Subject: Exchange of elevator hinge bolts

Effectivity: Glider ASTIR CS
all serial-no. 1001 to 1536

ASTIR CS

TM 306-17

Detail No.
 Abb.1

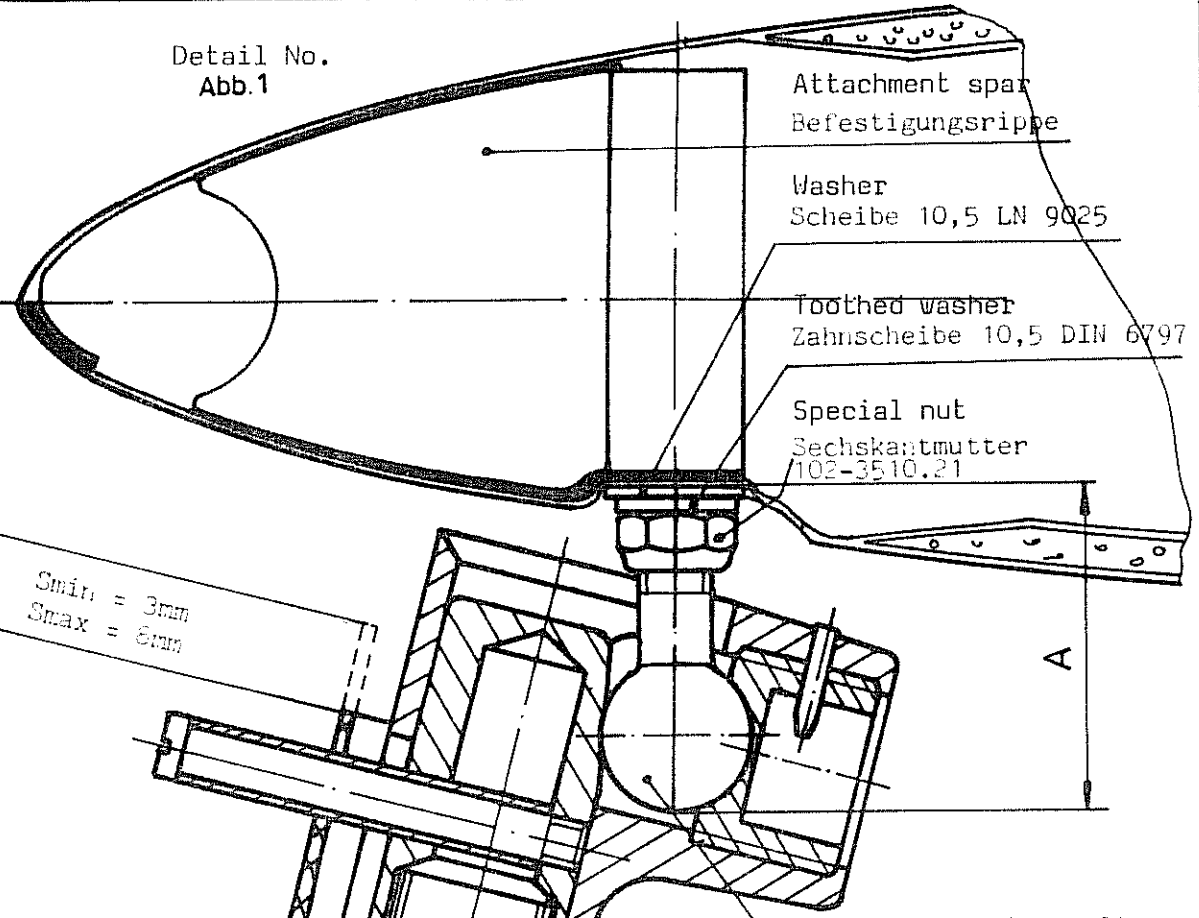
Instructions: 1. Replacement of the spheric locking bolt at the elevator leading edge (see detail 1 and 2)

- Remove the tail unit from the vertical stabilizer.
- Note the installation depth (A) of the used bolt to insure the correct installation of the replacement bolt in order not to change the elevator angle of incidence.
- Loosen the M10 - nut with the 14 mm wrench.
- Place the screwdriver into the slot of the ball and turn out the bolt.
- The new locking bolt (102- 3500.21) has rolled thread and requires a special nut (102-3510.21).

- Mount the modified locking bolt (102-3500.21) with a toothed washer 10,5 (DIN 6797 phr) and the nut (102-3510.21) according to detail no. 1. Adjust the bolt to the correct installation depth (A) and lock it by holding the ball with the screwdriver and tightening the nut with the wrench. Afterwards apply a small line of red color from the shaft of the bolt across the nut to the elevator surface to indicate unintentional rotation.

Detail No.
 Abb.3

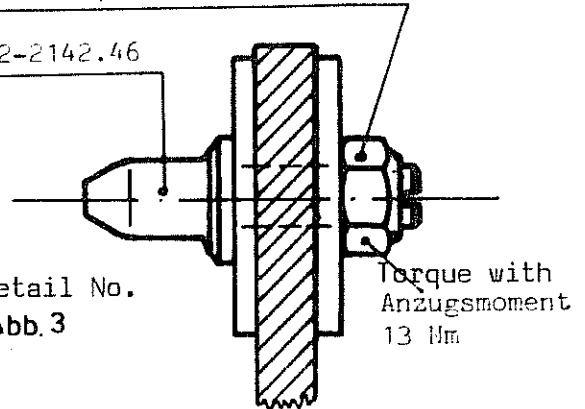
2. Replacement of the two retaining pins of the elevator hinge plate in the fin (see detail no. 3)

- Remove the tail unit (stabilizer and elevator) from the vertical stabilizer.
- Unscrew the 8 mm self-locking unit on the rear ends of the bolts with the 13 mm wrench. If the bolts turn with the nut, hold it in place with the screwdriver.
- Remove the loosened bolts and be sure that both washers remain on the hinge plate.
- Install the new bolts (102-2142.46) and make sure they are properly positioned at the washers according to detail no. 2. Use a new 8 mm self-locking nut so that the bolt is installed securely.

Caution: Do not tighten too far. If possible use a torque wrench and torque with 13 Nm (32"/lb)
